CUSTOMER NOTIFICATION

SUD-DT-04-0192 (1/15)
April 13, 2004
Koji Nishibayashi, Senior System Integrator Microcomputer Group 2nd Solutions Division Solutions Operations Unit NEC Electronics Corporation

IE-703107-MC-EM1
(Control Code: A, B, C, D, E)

Operating Precautions

No.13 Restriction on A/D converter

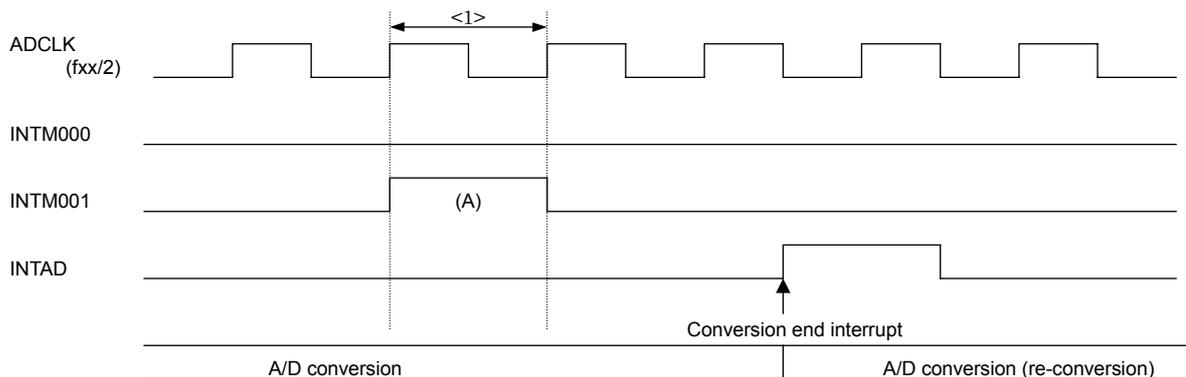
This restriction occurs when the timer 1 trigger mode or external trigger mode of the A/D converter is used (this bug does not occur when the A/D trigger mode or timer 4 trigger mode is used).

Originally, only INTM000 can be the trigger to start the A/D converter in the timer 1 trigger mode, and ADTRG pin input in the external trigger mode, therefore the interrupt sources listed below should be ignored. However, if one of the interrupt sources listed below occurs immediately before the end of A/D conversion (<1> in the figure below; 2 internal system clocks), it is mistakenly judged as the A/D conversion start trigger. As a result, A/D conversion is started again after the A/D conversion end interrupt (INTAD) is issued. The first A/D conversion ends correctly and the result is stored in the ADCRn register (this value can be read during the second conversion).

Note The external interrupt signal that functions alternately as the external capture trigger input of timer C (channels 0 and 1) can also be a trigger for re-conversion. In the case of an external interrupt input, this bug occurs when a valid edge is input before the timing of (A) in the figure below by the noise eliminator (analog delay (60 to 220 ns)).

Since the conversion result is correct even when this bug occurs, the affect of this bug is small when obtaining the latest conversion value. If the re-conversion causes any problems, start A/D conversion in the A/D trigger mode by setting the ADCE bit of the ADM0 register to 1 in the interrupt service routine of the timer match interrupt.

No.14 Bug in _HLDK signal output

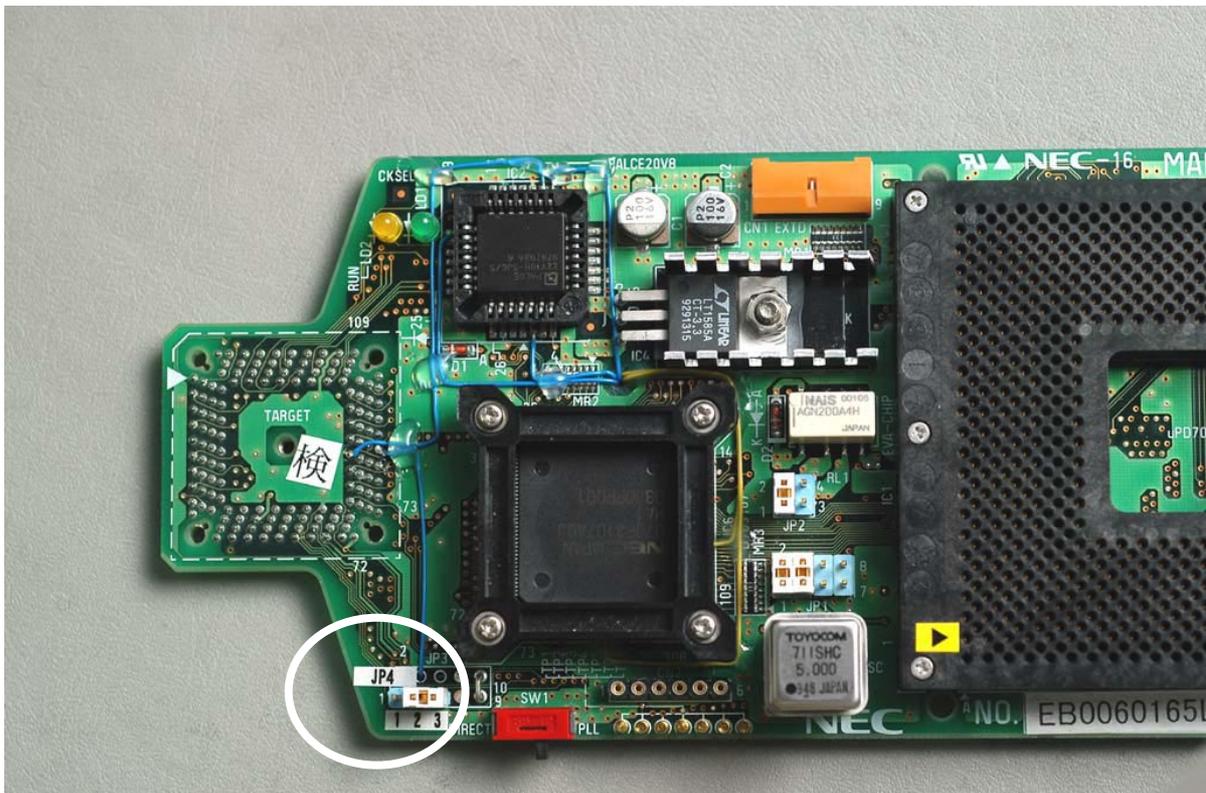
The _HLDK signal output from the emulator in response to the _HLDRQ signal from the target system may be illegal (there are two cases).

This bug occurs only when output of the _HLDK signal and refresh conflict.

The function of JP4 that is provided in control code E (V1.33) is described below.

2-3 shorted: Setting to prevent _HLDK illegal output

1-2 shorted: Setting functions other than above (factory setting)

(1) Set 2-3 shorted only for the following system.

- A system in which DRAM or SDRAM is connected to the external bus and the bus hold function is used.

(2) Set 1-2 shorted for systems other than above.
